3GPP TSG SA WG3 Security — S3#10
19-21 January, 2000
Antwerp, Belgium

LS on Authentication Failure Report

TS 33.102 CR 049

Authentication failure reporting

Figure 13: Reporting authentication failure from VLR/SGSN to HLR

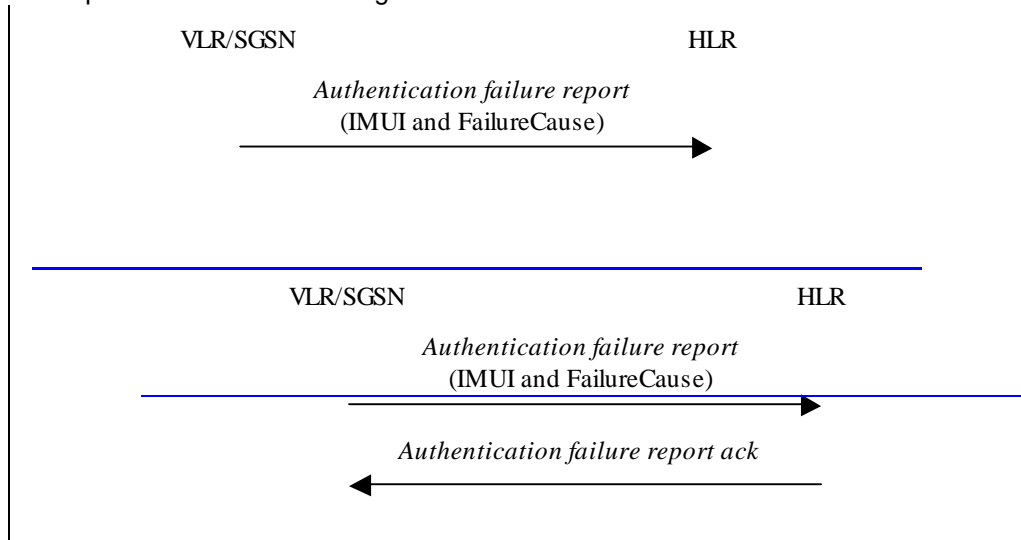
The *Authentication Failure Report* from the SGSN/VLR does not need to be acknowledged by the HLR and consequently the acknowledge should be removed.

~~When the home environment receives the *authentication failure report* it shall respond by an acknowledge back to the serving network.~~ The HE may decide to cancel the location of the user after receiving an *authentication failure report*.
